## PLAT COMMITTEE

<b>Case Number:</b>	2023-PLT-038
<b>Property Address:</b>	17 Parkview Avenue ( <i>Approximate Address</i> )
<b>Location:</b>	Center Township, Council District #17
<b>Petitioner:</b>	19 Parkview LLC, by Jynell D. Berkshire
<b>Zoning:</b>	D-8
<b>Request:</b>	Approval of a Subdivision Plat, to be known as Rose's Parkview Avenue Addition, dividing 0.095-acre into two single-family attached lots.
<b>Waiver Requested:</b>	None
<b>Current Land Use:</b>	Two-Family Dwelling
<b>Staff Reviewer:</b>	Allison Richardson, Senior Planner

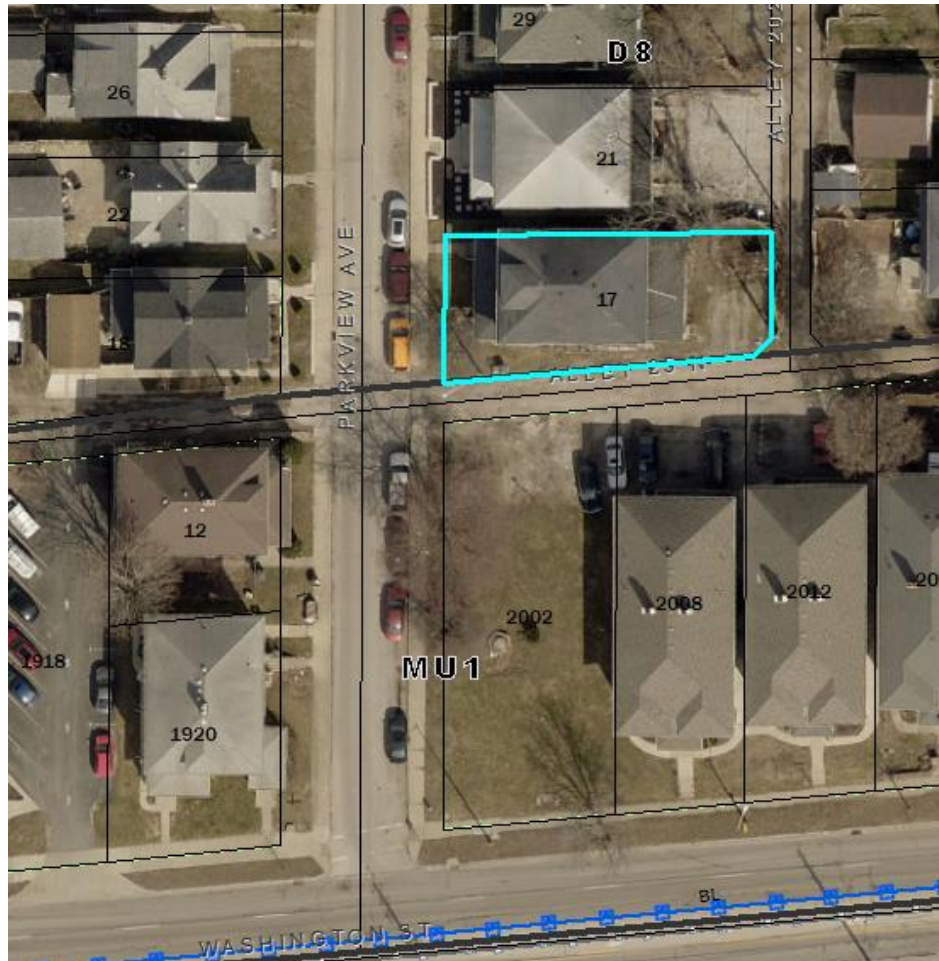
The subject site is zoned D-8 and developed with a two-family dwelling. This proposed plat would divide the existing parcel into two lots. Lots One and Two would each contain half of the two-family dwelling with the lot line following the common wall and continuing through the rear of the lot. The subject site has been developed with a two-family dwelling since at least 1915 as shown on historic Sanborn Maps. This replat would allow the property owner to sell each of the parcels individually, rather than as one parcel, with minimal impact on the surrounding property owners.

Lots One and Two would front on Parkview Avenue, with alley access on the side and rear. No new streets are proposed.

Staff recommends that the Plat Committee **approve** and find that the plat, file-dated May 22, 2023, complies with the standards of the Subdivision regulations, subject to the following conditions:
